Portugal Street East, The Fairfax

Design Justification Statement

The following presentation has been produced to set out the developed design compared to the approved planning drawings. The drawings are all labelled with reference to Schedule 1.0 which sets out the design revisions.

Block 1, 29th Floor Plan - Proposed Design

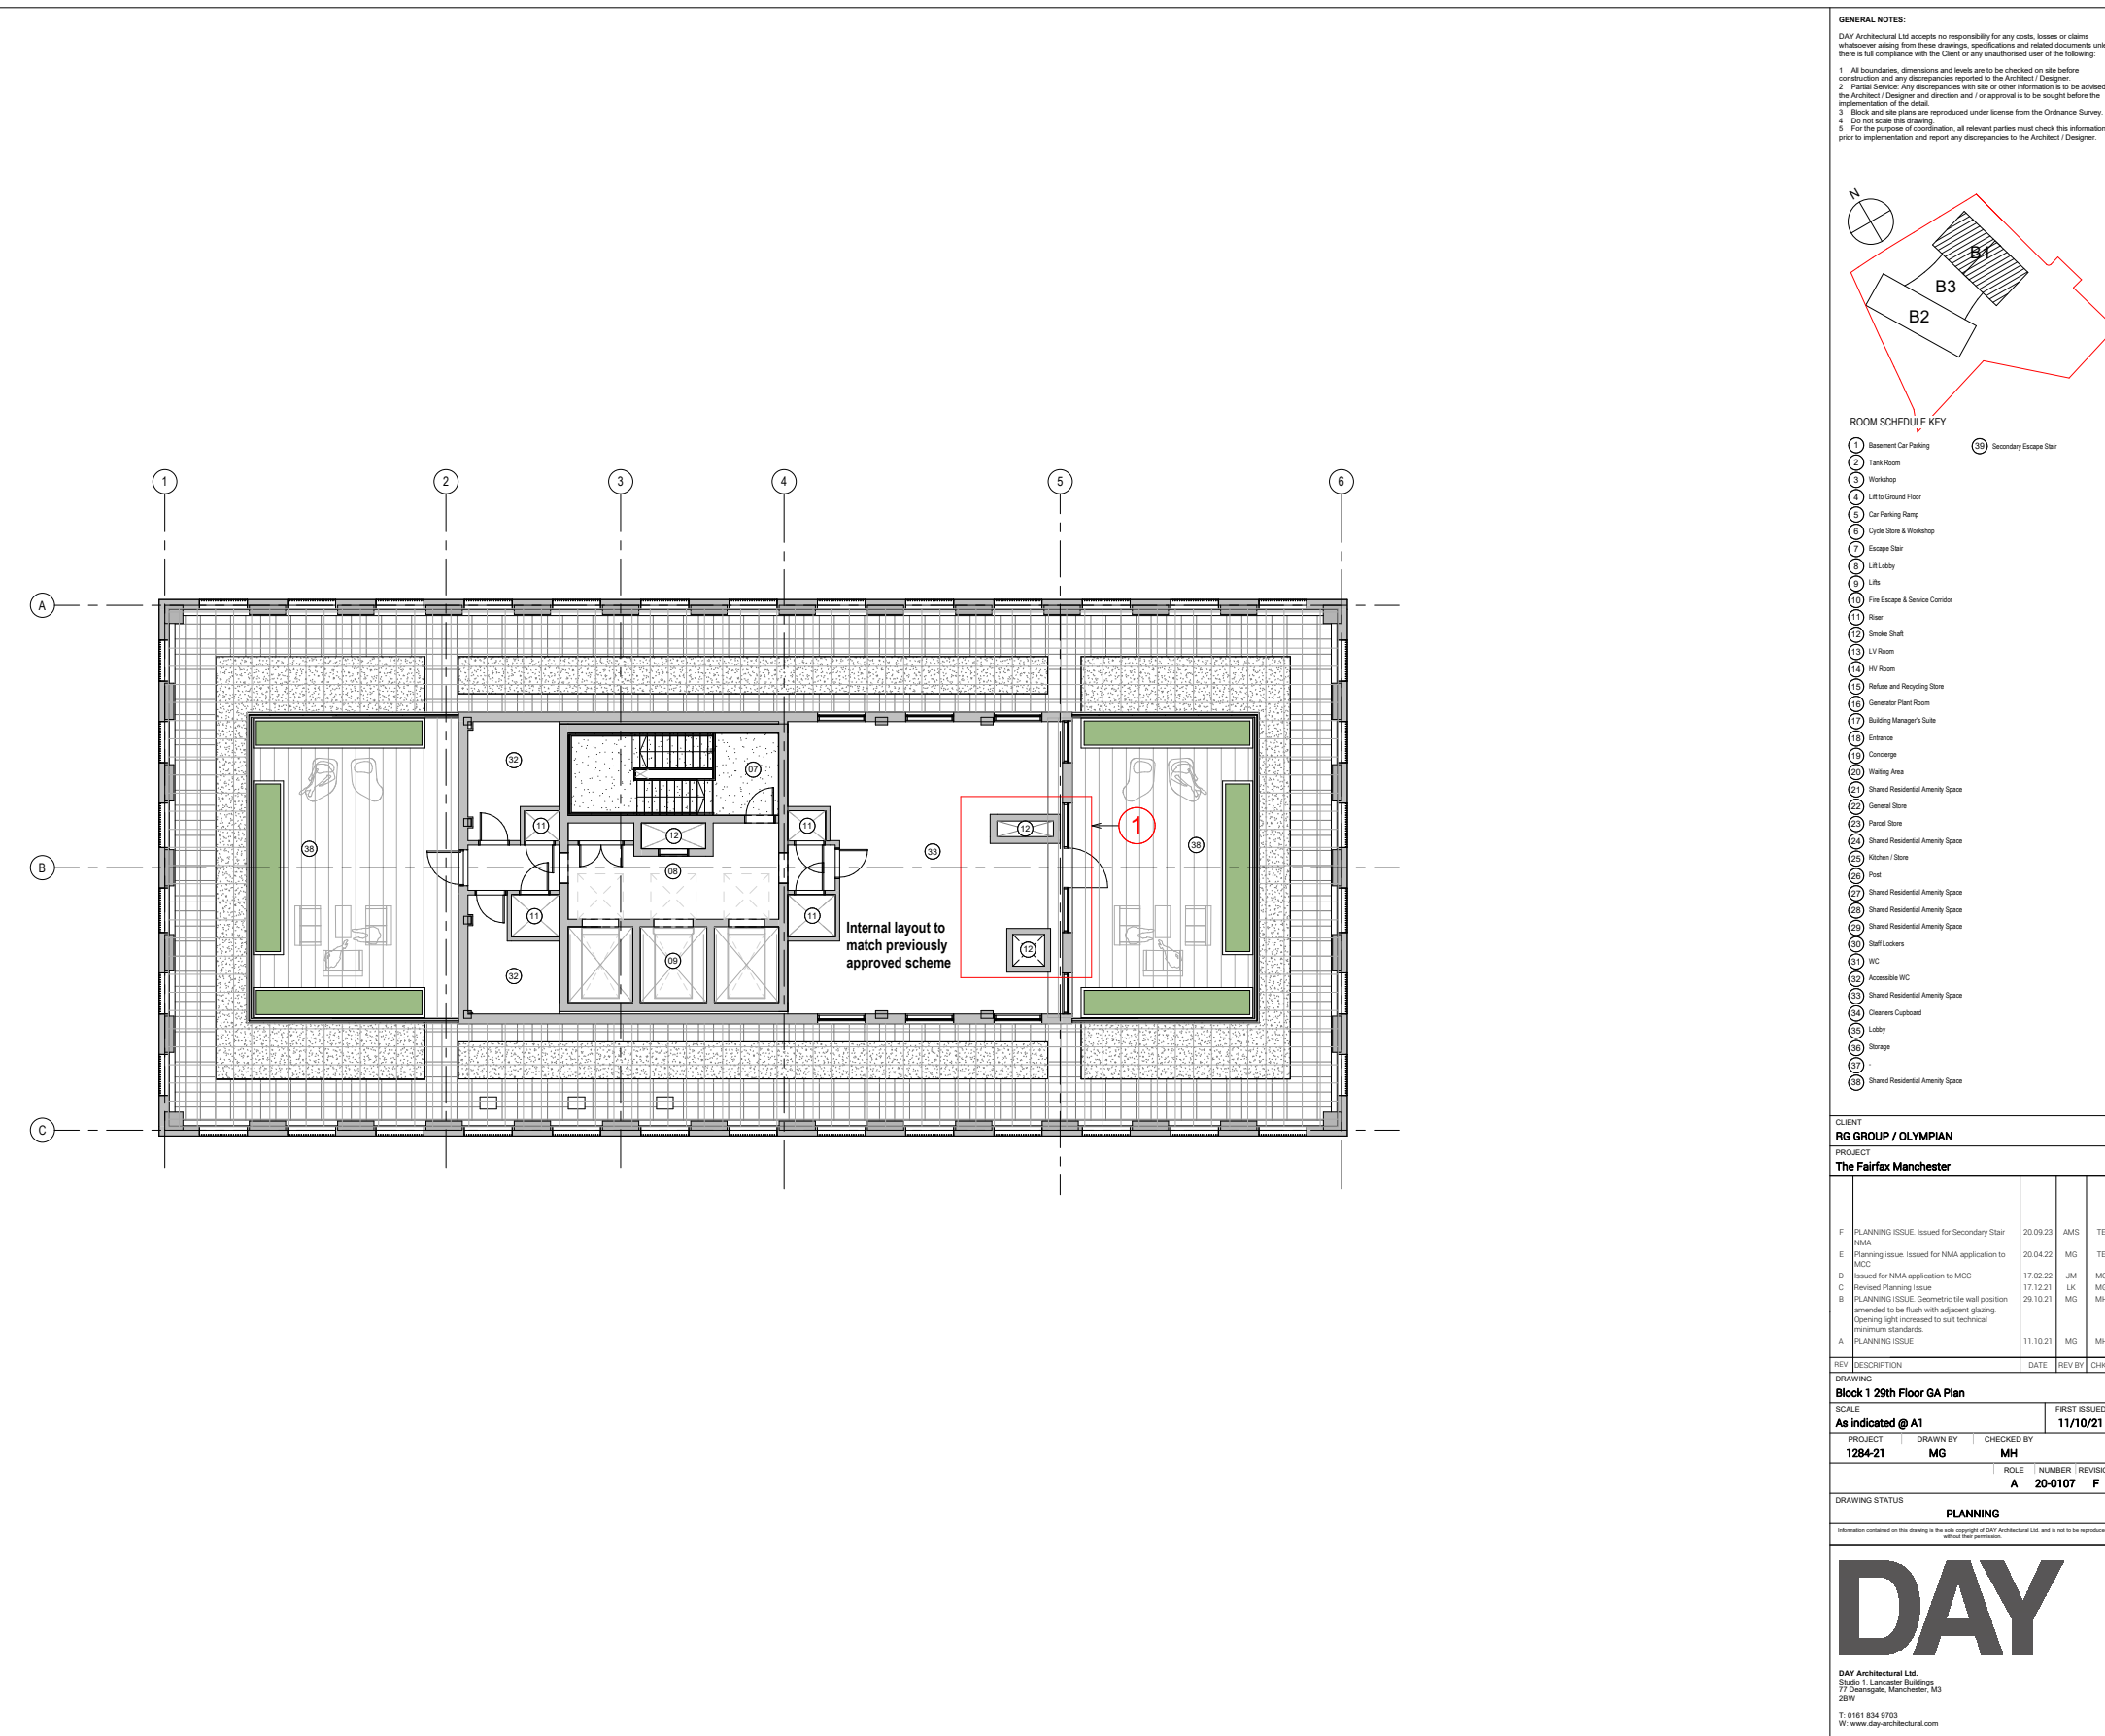
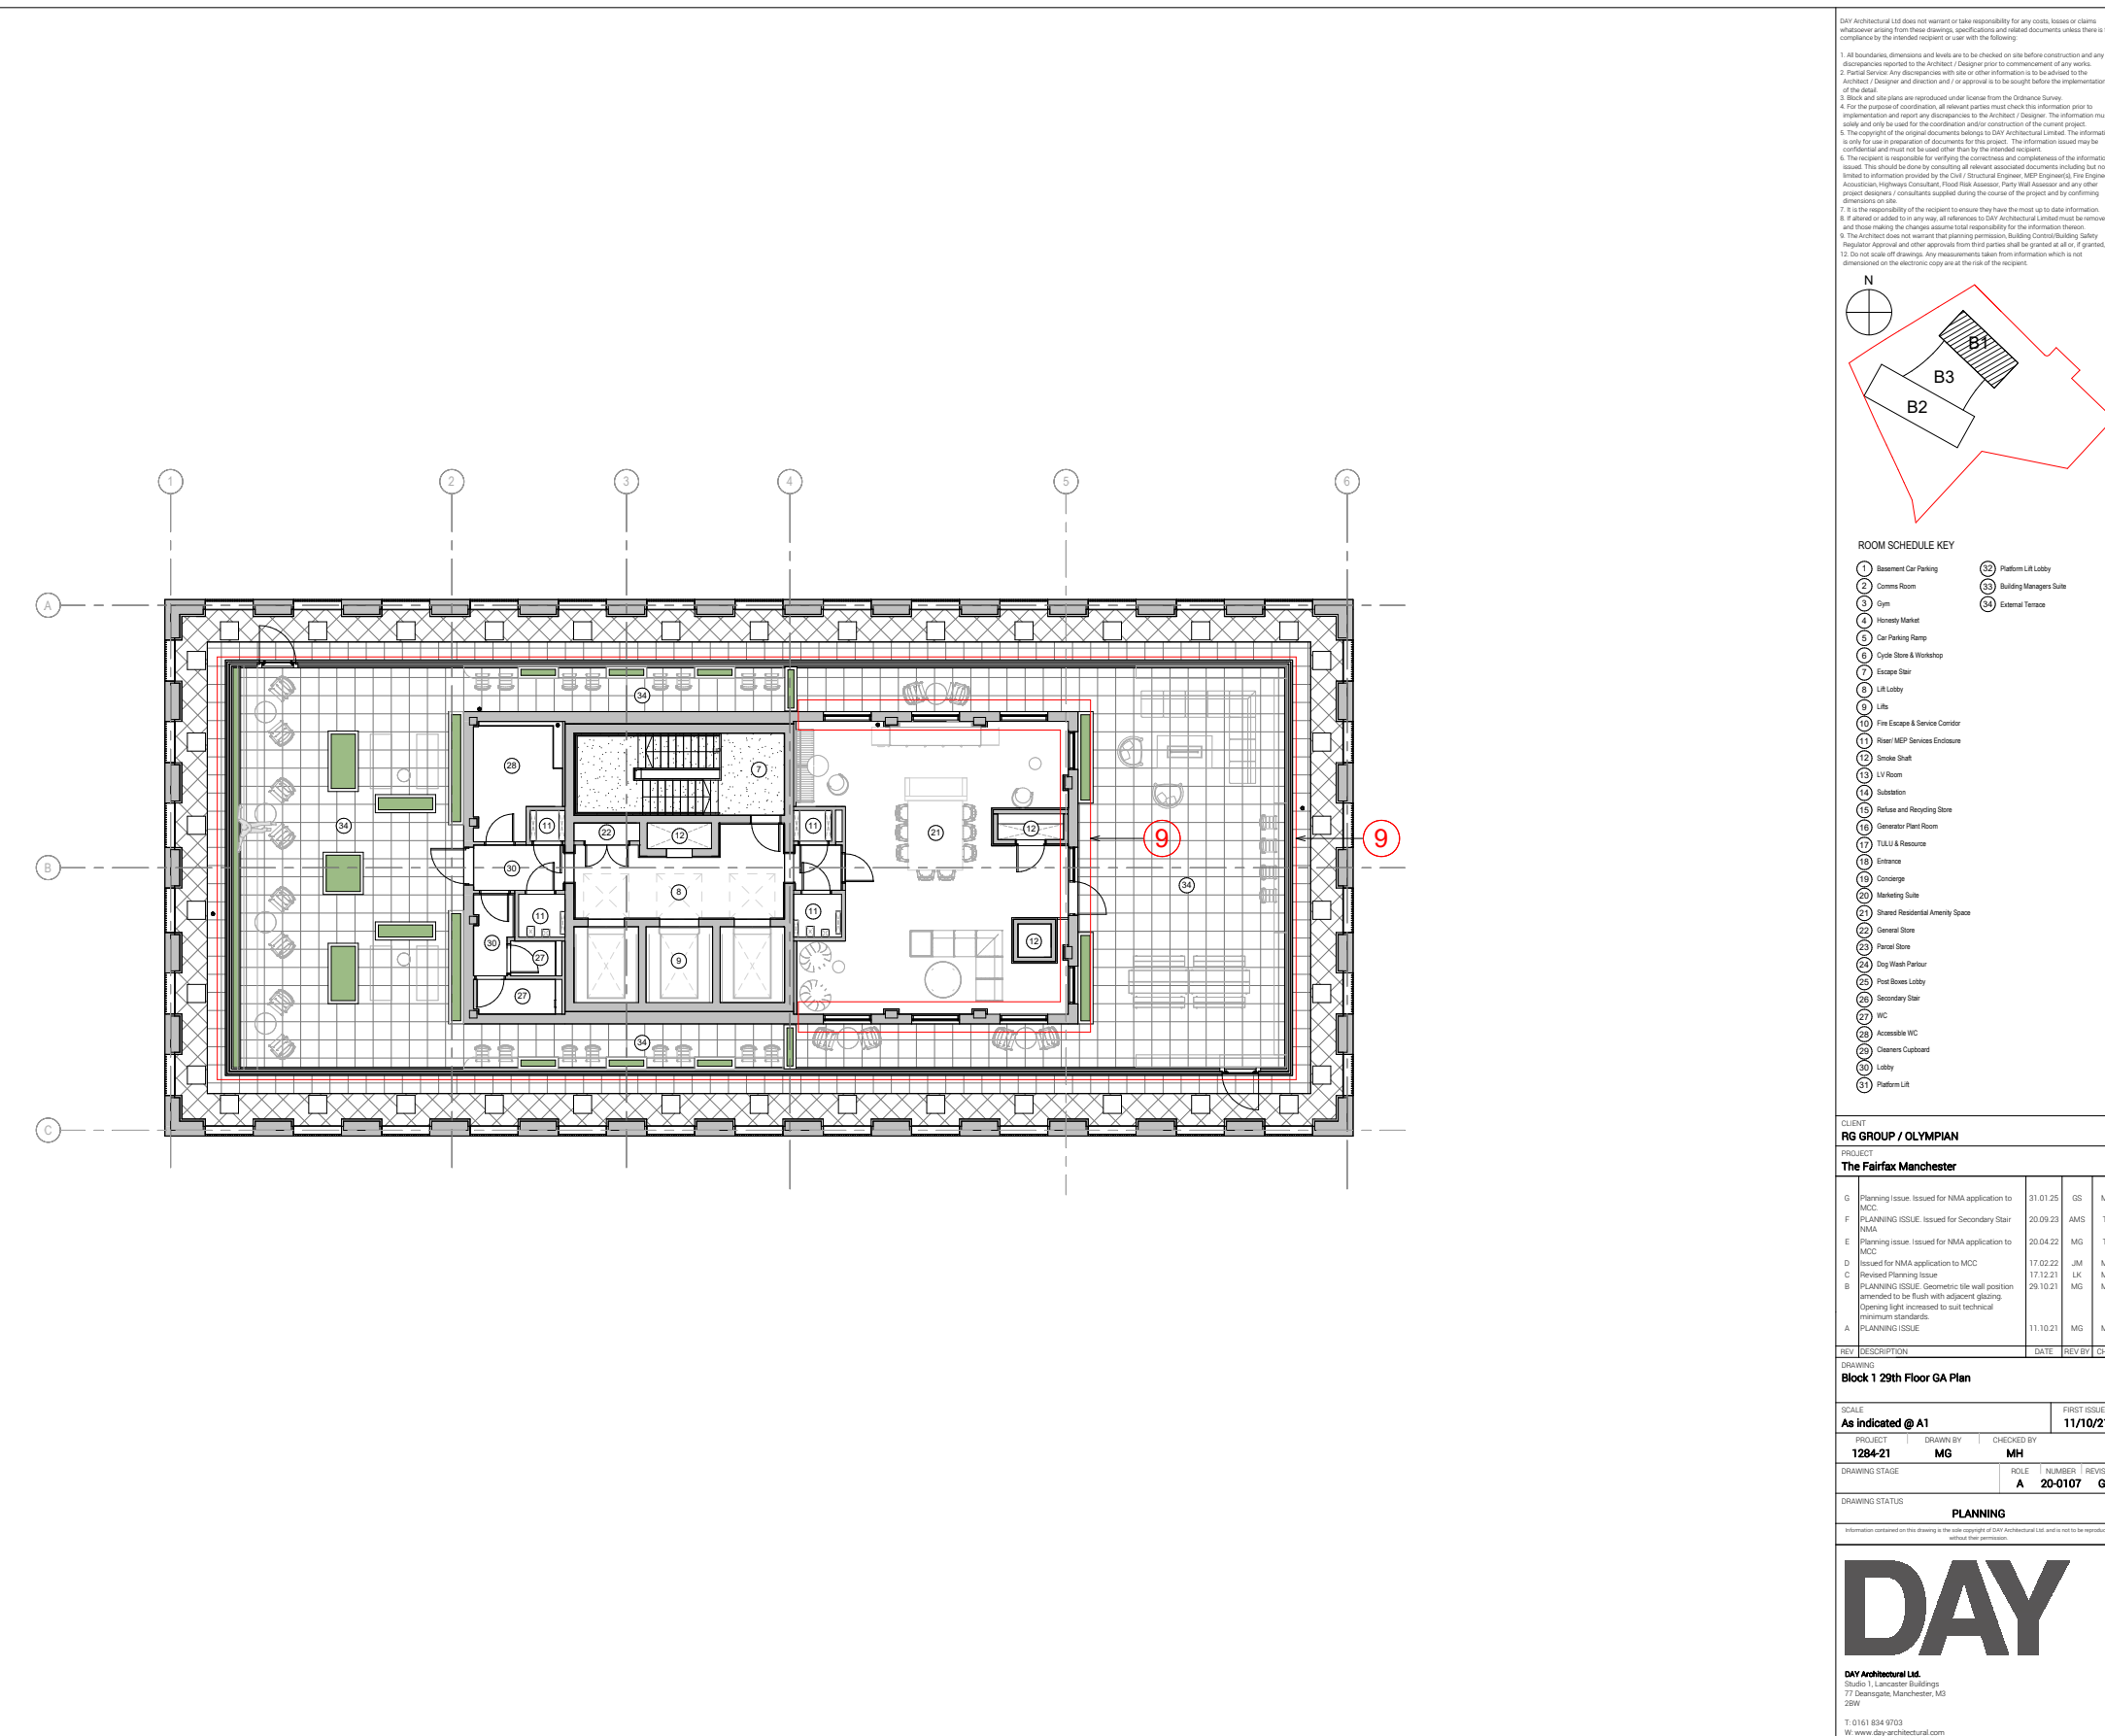
9	Block 01 Level 29 amenity space	Size of roof terrace increased to provide additional external amenity and design of external elevations finalised	The roof terrace has been increased in size by 150m2 to maximise the external amenity provision and provide panoramic access, whilst ensuring a sufficient secure external maintenance area is retained for maintenance access and operation purposes	20-0103 REV E 20-0107 REV F 20-0108 REV F	20-0103 REV F 20-0107 REV G 20-0108 REV G 20-0515 REV A
10	Block 01 and 02 emergency egress escape doors and screens	Amendments to external elevations (approved under NMA application reference 138154/NMC/2023)	To amend the approved elevations to reflect the changes agreed under NMA application reference 138154/NMC/2023	20-0203 REV E 20-0205 REV E	20-0203 REV F 20-0205 REV F
11	Block 01 additional door	External door added in place of fixed glazed unit. Size of opening remains as per approved design	Internal arrangement has changed to provide a residents only use dog grooming facility. External door added to provide external access for residents to the residents to avoid having to access via the main entrance and circulation route	20-0203 REV E	20-0203 REV F
